A388 Hatt

Rood's Corner Route Review Report

Infra22-068-CSL-ENM-SX397596-RP-D-0001-A388 Hatt Review Report

Figure 2.1. Hatt Roundabout to Rood's Corner (Option A-Section 7)

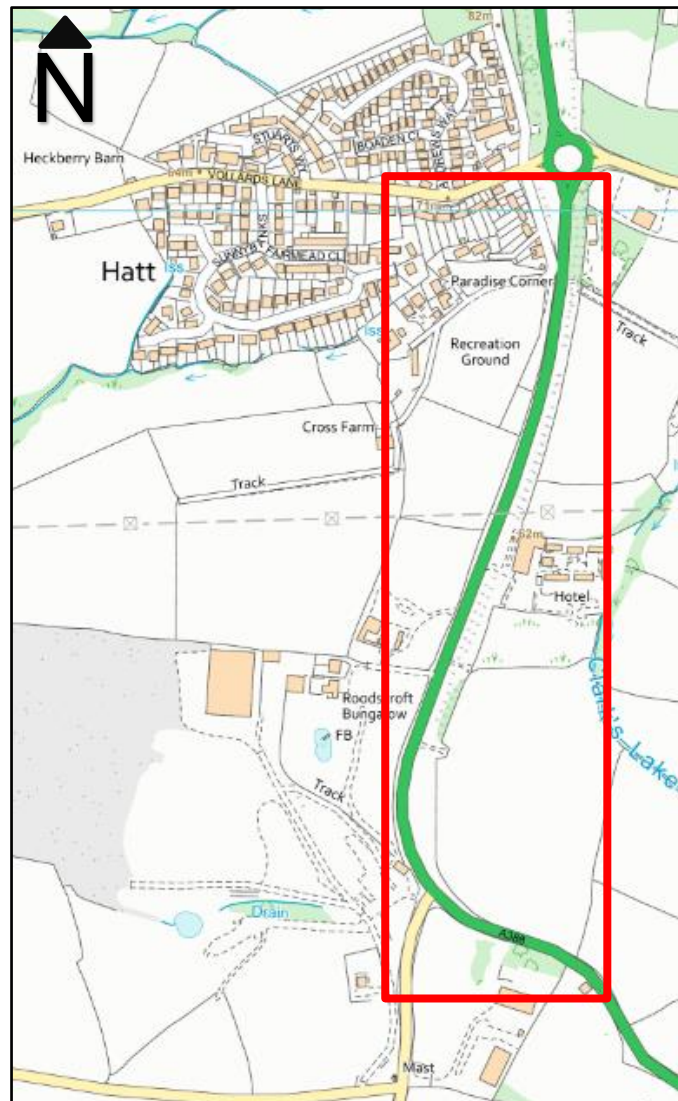
- 2.1.5 The feasibility study proposed to improve the crossing point on the southern side of Hatt Roundabout to better assist the pedestrians and cyclists and to provide a shared route on the east of the A388 to Rood's Corner. Another crossing point was recommended at Rood's Corner junction to link the route to new developments which will be located on the south of the A388. A roundabout is proposed at this location as part of the nearby housing development. The speed limit on this section of the road is 60mph which should be carefully considered during the detailed design stage of the scheme.

- 2.1.6 The Callington to Saltash Safe Passageway report proposes a shared use cycle /footway which is unsegregated, 3m wide and surfaced with bitmac. The study recommends a grass buffer strip of at least 1m between the shared route and the main carriageway, as the A388 is a busy road with high-speed traffic. The study also recommends improving the existing pedestrian refuge at Hatt Roundabout to create a cycle friendly crossing provision.

- 2.1.7 The existing pedestrian refuge to the south of Hatt roundabout could be extended to the south and widened to accommodate a staggered Toucan crossing with two independently controlled crossing points. This would need to be set back from the roundabout to allow traffic stacking distance at the crossing without hindering traffic at the roundabout. This would add significant cost compared to an uncontrolled crossing.

Figure 3.1. Hatt Roundabout to Carkeel (Sustrans – Option 5)

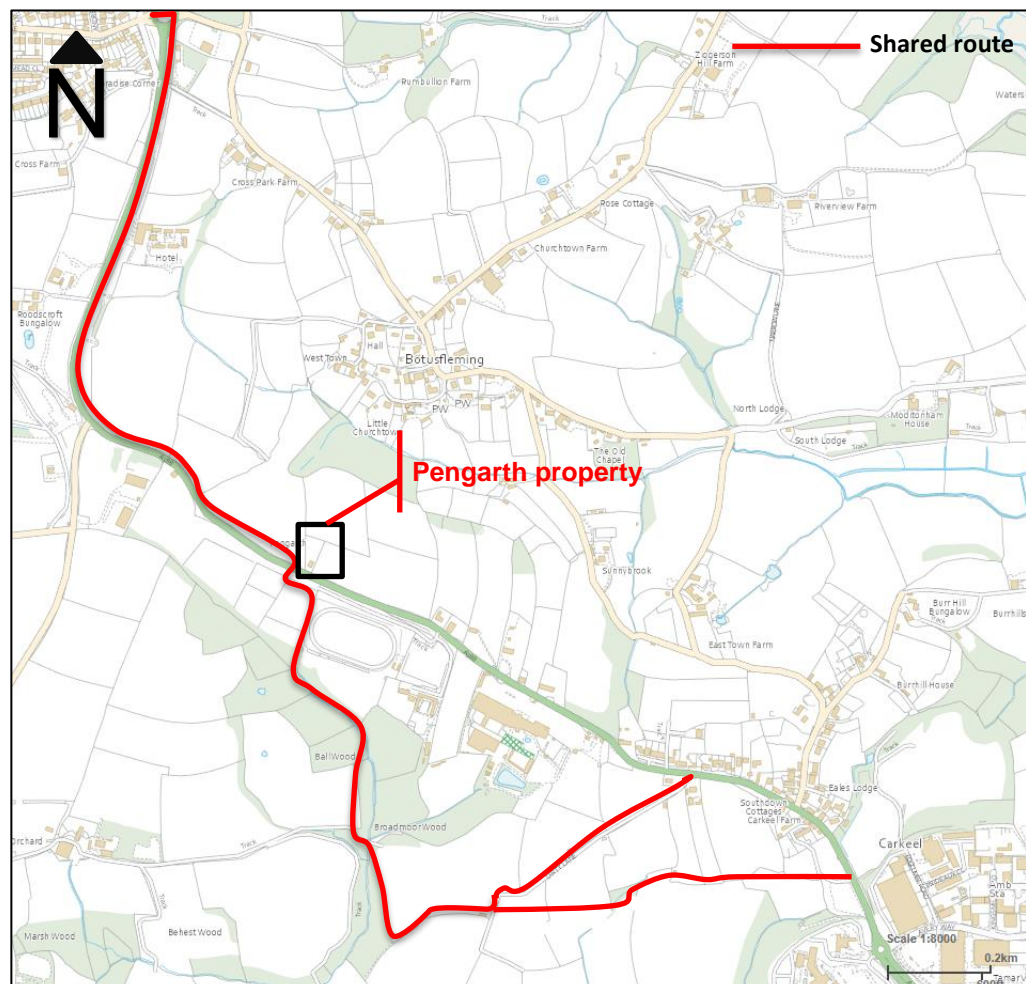
- 3.1.3 This study recommends a 3m wide path with a bound surface throughout the route to provide a high quality, smooth, and well-drained walking and cycling surface. The study proposes that the route will be parallel to the A388 including directional signs with distances of main destinations. In addition to this, the study recommends that the eastern side of the carriageway has a potential to provide a 5m wide route.
- 3.1.4 Section 4 and Section 5 will investigate the details of both 3m and 5m wide routes and the existing conditions along the A388.

Figure 5.4. Land registry within the area of Recycling Centre

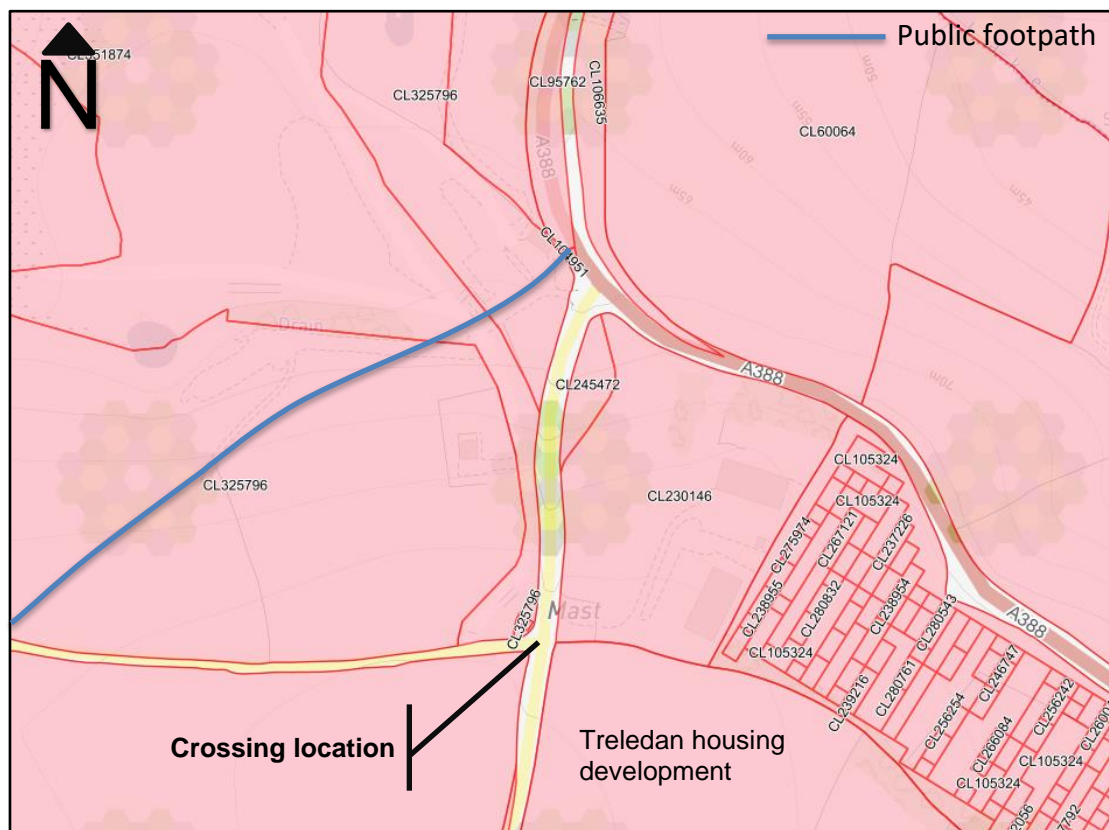
- 5.1.6 An alternative to upgrading the footpath is to use the existing Recycling Centre Access Road which provides a more direct route to the Treledan development. However, this would require land negotiation with the two landowners within this area (Refer to Figure 5.4). This will add additional cost to the scheme and there is no guarantee this would be successful. Additionally, it should be noted that the access to the Recycling centre will be used by large vehicles. Therefore, careful consideration should be given to the location of warning signs, lighting of the route, and additional safety features where possible.
- 5.1.7 The footpath has a less steep gradient than the recycling centre access road making upgrading the footpath a better option for cyclists.

- 5.1.8 Both the footpath and the access road lead to the quiet lane to Notter. At the eastern end of this lane, it is proposed to provide a crossing point to the Treledan development (Refer to Figure 5.4). It is recommended that the visibility on both approaches to this location is improved. Furthermore, traffic calming is recommended to improve safety for pedestrians and cyclists at this location.

Figure 6.5. The boundary of BAP and CWS

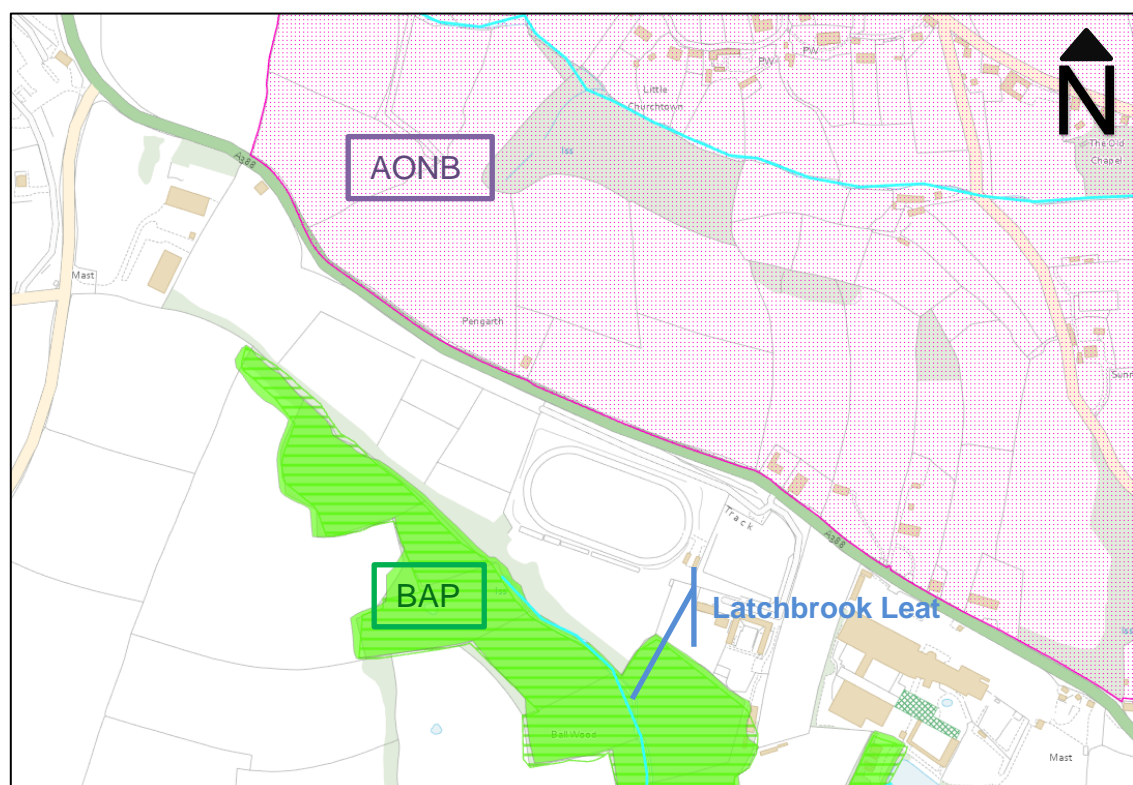
- 6.1.5 To the south of this proposed crossing point, the Sustrans report recommends that the shared route will continue to Ball wood and Broadmoor wood following Latchbrook Leat and will link via two routes in to the A388 (Refer to Figure 3.1). According to Cornwall Council Intranet mapping, the route would be within the Biodiversity Action Plan (BAP) area and County Wildlife Sites (CWS) (Refer to Figure 6.5).

- 6.1.6 Therefore, Cornwall Wildlife Trust has been contacted in order to investigate the existing conditions and constraints of the Broadmoor and Ball Woods County Wildlife Site with an ID No. CN23. Following this, it is understood that Broadmoor and Ball CWS is privately owned and there is no existing path within the boundary of the site. Moreover, it is suggested not to construct any path within the boundary of the CWS as it will increase the human activity which will result in major disturbance to the wildlife and the construction of the path will cause habitat loss (Refer to Appendix F). Therefore, the Sustrans route will not be considered further as a possible shared route (Refer to Drawing 3).
